PLAN-006841

Proposal: Change of use from agricultural land to provide 4 No permanent plots for travelling show people and a pony paddock. This application is a departure from the Development Plan.

Site: Land at Aldingbourne Farm Shop, Nyton Road, Aldingbourne, PO20 3TX.
AL/47/14/PL

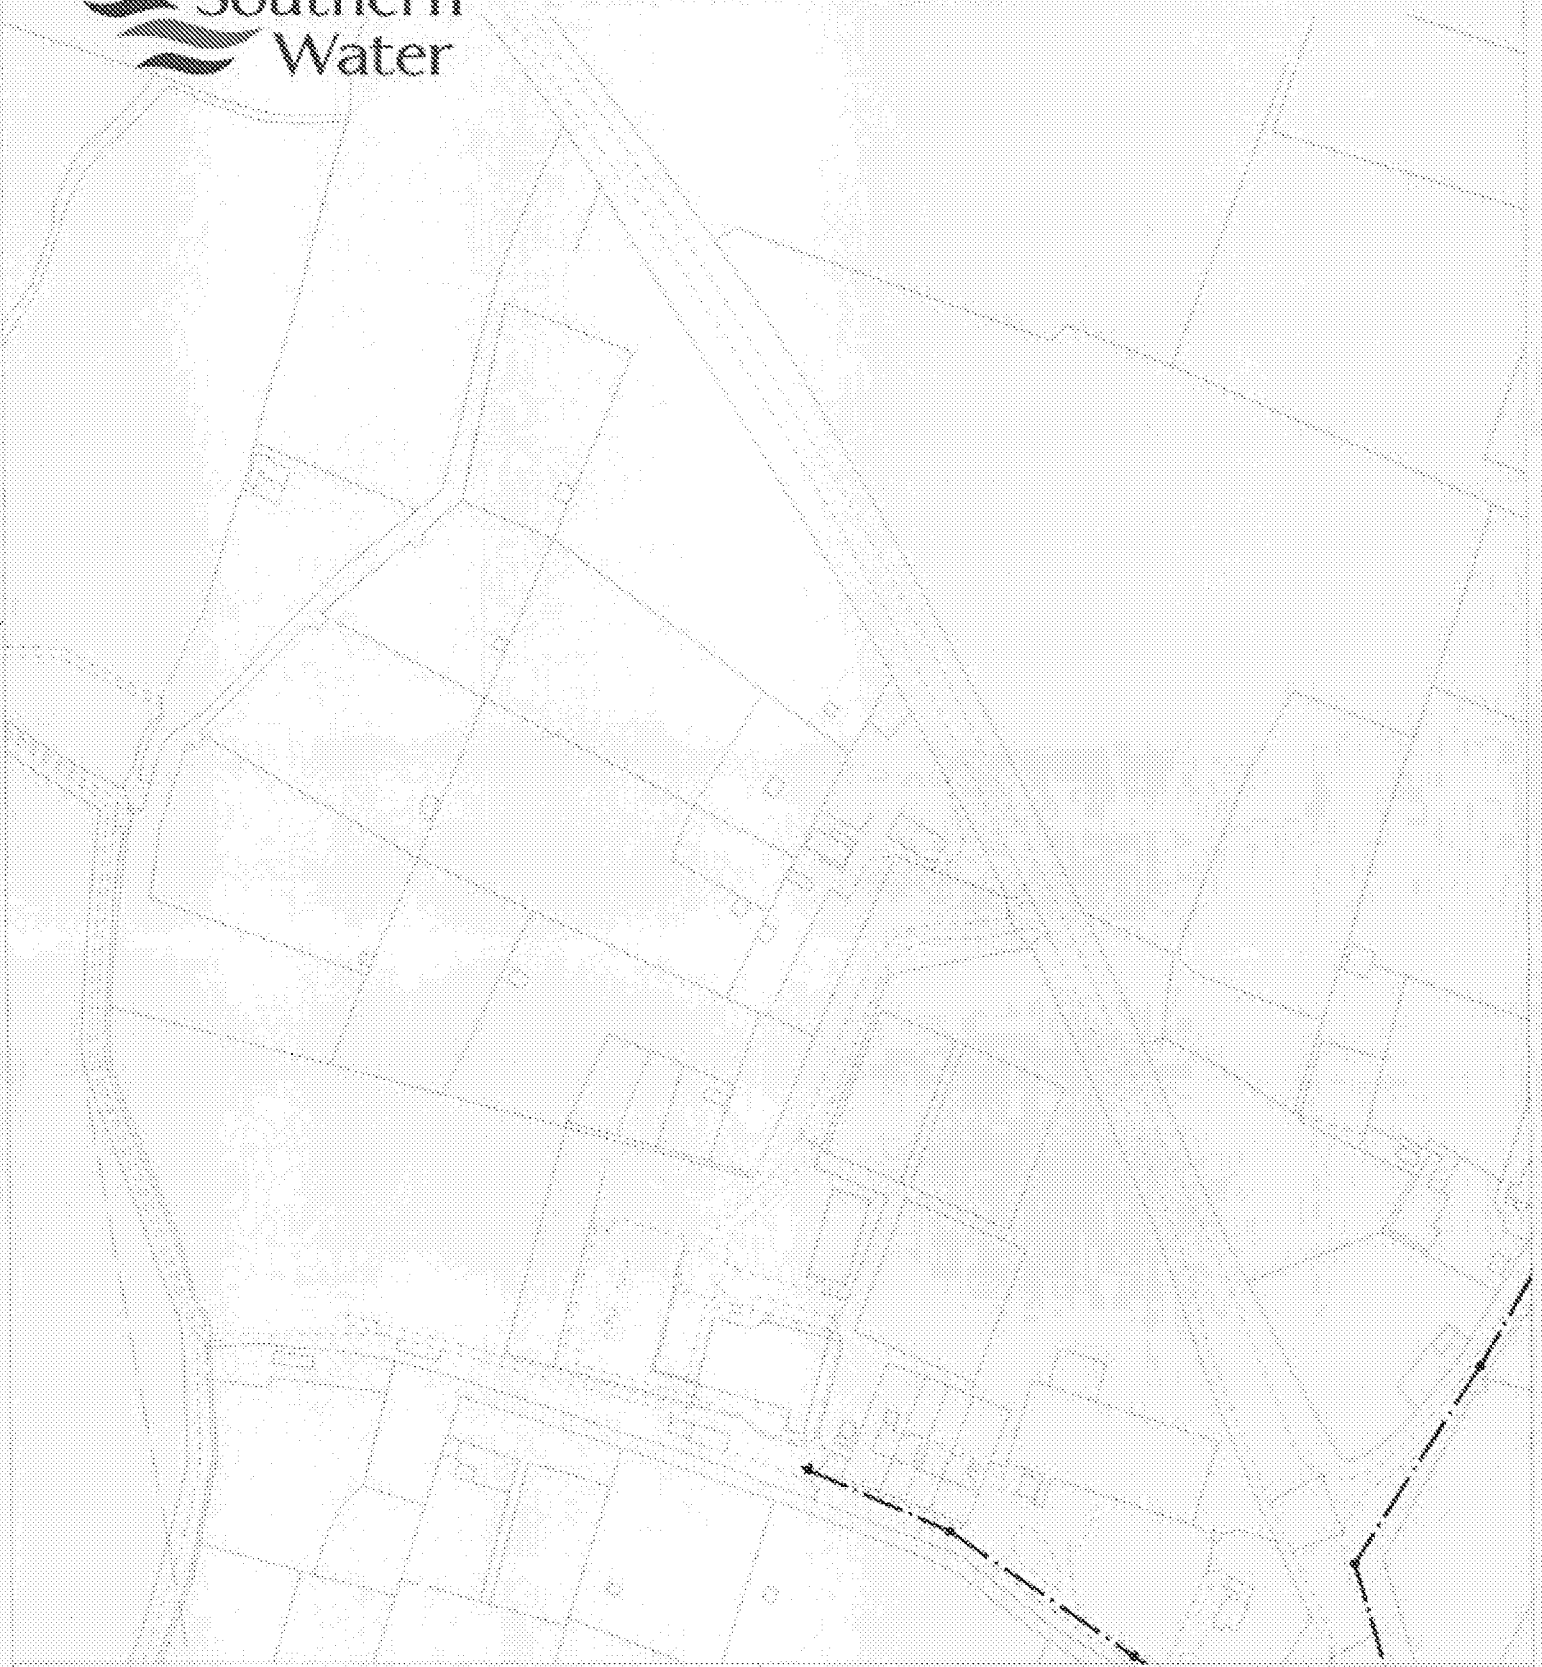
Our initial investigations indicate that there are no public surface water sewers in the area to serve this development. Alternative means of draining surface water from this development are required. This should not involve disposal to a public foul sewer.

Due to changes in legislation that came in to force on 1st October 2011 regarding the future ownership of sewers it is possible that a sewer now deemed to be public could be crossing the above property. Therefore, should any sewer be found during construction works, an investigation of the sewer will be required to ascertain its condition, the number of properties served, and potential means of access before any further works commence on site.

Developer should look to protect the public sewerage system from inundation and infiltration, which contribute to flooding in unfavourable conditions.
